**TOWN OF ADDISON
BUILDING REPORT**

Facility Information: **Facility Name:** Tree House
Facility Contact: Lisa Pyles **Contact Phone:** 972-450-2878

Accessology Inspector Information:
Inspector: Karen Jackson **Date:** April 4, 2016
Email: Kjackson@accessology.com

Latitude: 32.947856 **Longitude:** -96.84084
Address: 14681 Midway Road, #200 **City:** Addison **County:** Dallas

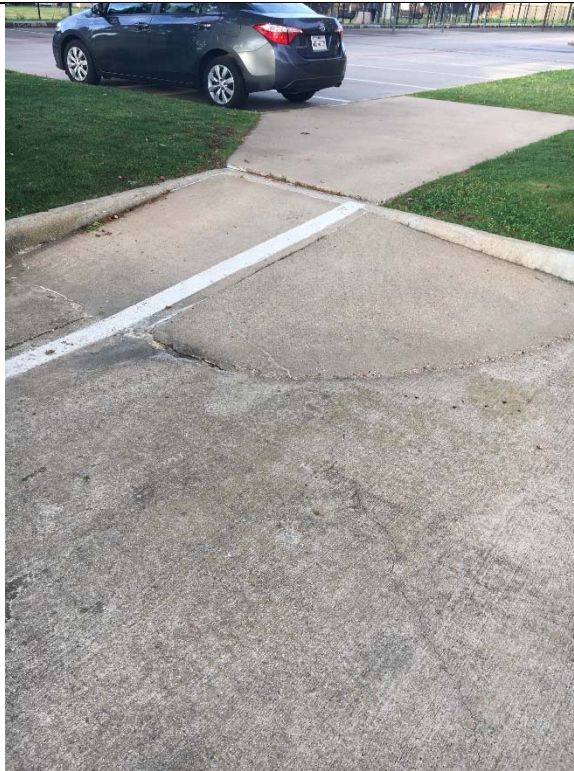
Violation 1 - The accessible parking space has a running slope of 3.8% and a cross slope of 2.4%.

Relocate accessible parking. Ensure slopes are no greater than 2% in all directions.

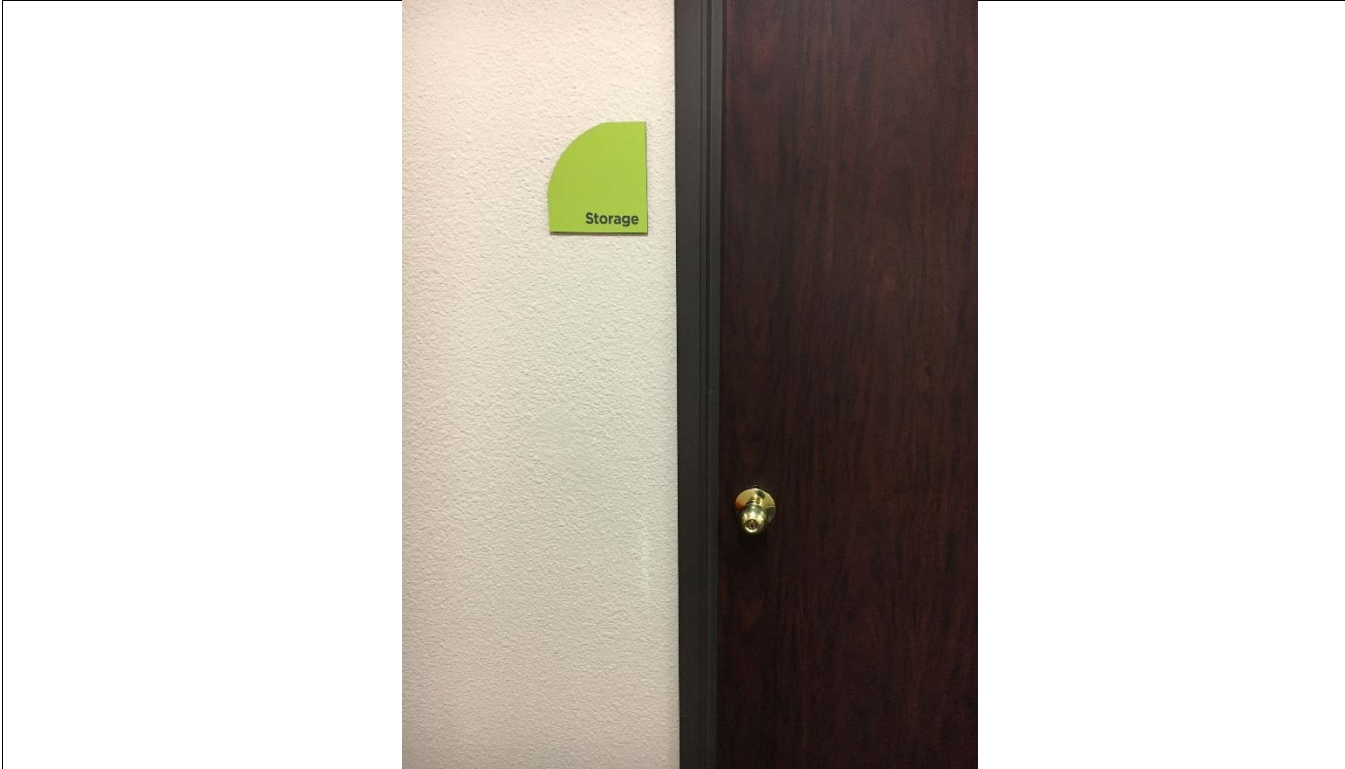
Violation 2 - The access aisle is only 38" wide and has a built up curb ramp in it.

Violation 3 - The curb ramp provided projects into the access aisle and the accessible parking space and has a running slope of 11.4%.

Violation 4: - There is only 1 accessible parking space provided, with the parking count, 3 are required.

Add compliant access aisles that fully complies with 502.3 with slopes no greater than 2% in all directions.

When parking is reworked, install a compliant curb ramp complying with sections 405 and 406.

Add two parking spaces and ensure one is van accessible with compliant signage. Two of the accessible parking spaces can share an access aisle.

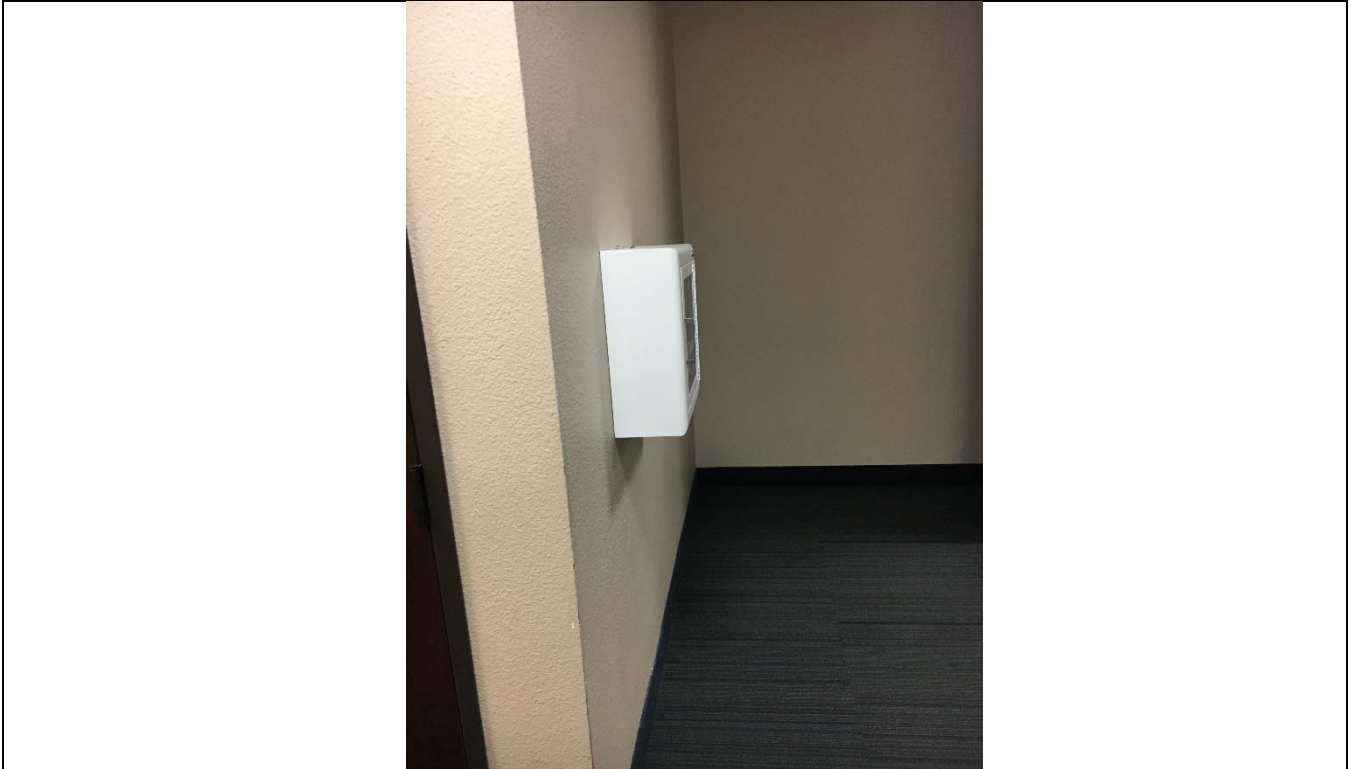
Violation 5 - There is a 5'-0" ramped area where the sidewalk meets the brick pavers that has a running slope of 16.1%.

Violation 6 - The supply and storage rooms in the main hallway have knob door hardware.

Remove portion of the sidewalk leading up to the brick porch and extend the slope to provide a sidewalk with a running slope of less than 5%.

Replace door hardware with lever type hardware that does not require tight grasping or twisting to operate.

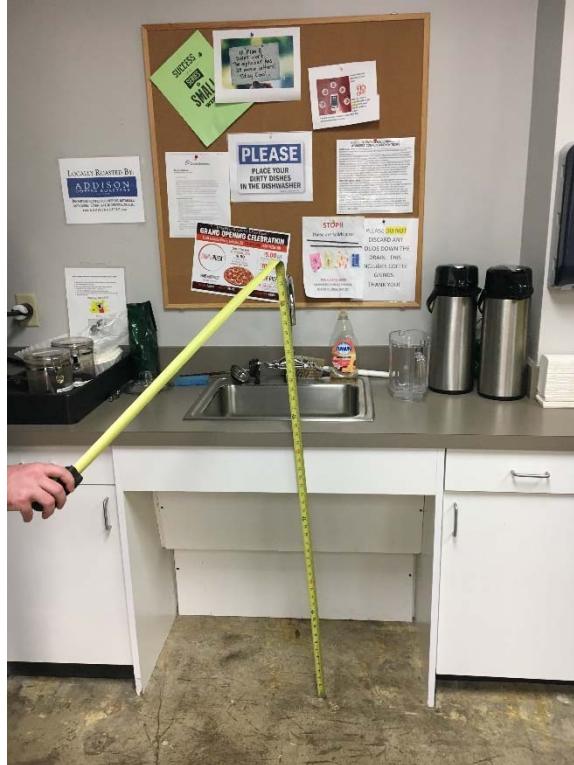
Violation 17 - Men's restroom lavatory pipes are not wrapped.

Provide protection at the exposed drains and water lines under the lavatory.
